Request for Additional Information 567, Supplement 1

U. S. EPR Standard Design Certification

SRP Section: 03.02.02 - System Quality Group Classification

Question 03.02.02-15:

Figure 03.02.02-15-1—RPV Cavity Seal Ring Layout

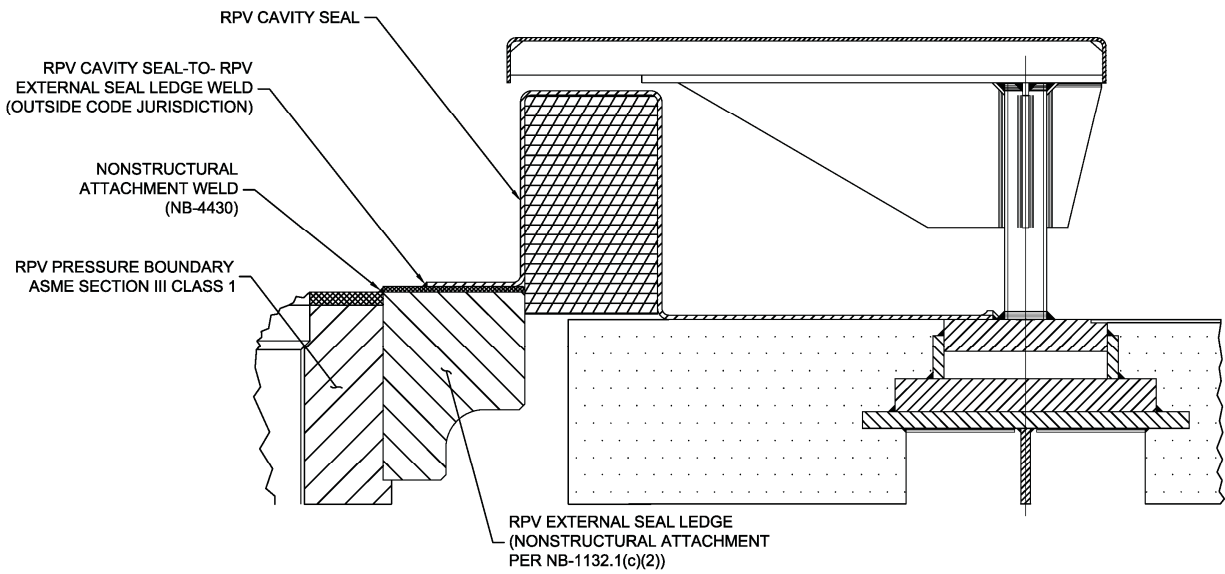
EPR RPV Refueling cavity ring

The response to RAI 504 (5982), Question 03.02.02-14 clarified that the RPV refueling cavity ring is a not a pressure retaining component, and as a result quality group (QG) and the ASME Section III Code do not apply, but the design is to ASME Section III with no Code certification or stamping required. FSAR Tier 2 Table 3.2.2-1 shows the cavity ring as QG NA, but no code or code class is identified. Although staff agrees that a QG is not required for a component that is not pressure retaining or supporting a pressure retaining component, the ASME Section III Code does include attachments, and the boundary for attachments is to be defined in ASME design specifications. Further, there should be an ITAAC or other verification method to ensure the correct classification and integrity of the attachment weld. Therefore, the applicant is requested to:

- (a) clarify the ASME Code Class jurisdictional boundary for the attachment to the ASME Section III Class 1 RPV
- (b) confirm that an ITAAC or other verification applies to the attachment weld to the RPV
- (c) clarify in FSAR Tier 2 Table 3.2.2-1 that the design of the cavity ring is to ASME Section III with an appropriate ASME Code Class, but without ASME Code certification (with reference to the appropriate FSAR Section where the refueling ring design basis is discussed)

Figure 03.02.02-15-1–RPV Cavity Seal Ring Layout, shows an illustration of the parts and welds discussed in the response.

- (a) The reactor pressure vessel (RPV) refueling cavity ring is attached to the external seal ledge of the RPV. The design specification for the RPV classifies the external seal ledge as a nonstructural attachment. Nonstructural attachments to pressure retaining material are governed by ASME Code Section III rules. See Figure NB-1132.2-2. The external seal ledge corresponds to Item 5 in this figure, and its attachment weld corresponds to Item 6. The refueling cavity ring is an attachment to a nonstructural attachment to an ASME Code Section III pressure vessel; and is, therefore, outside of ASME Code Section III jurisdiction.

- (b) The weld between the RPV external seal ledge and the RPV is within the scope of the RPV Design Specification. Therefore, verification of this weld is included in Commitments 3.26 and 3.30 of the U.S. EPR FSAR Tier 1, Table 2.2.1-5–Reactor Coolant System ITAAC.

- (c) The RPV refueling cavity ring is not an ASME Code component. It is not within the scope of Section III, and cannot be constructed such that it would comply with any code class within Section III, Division 1. Two examples of Section III, Division 1, rules that could not be met are hydrostatic testing and overpressure protection.
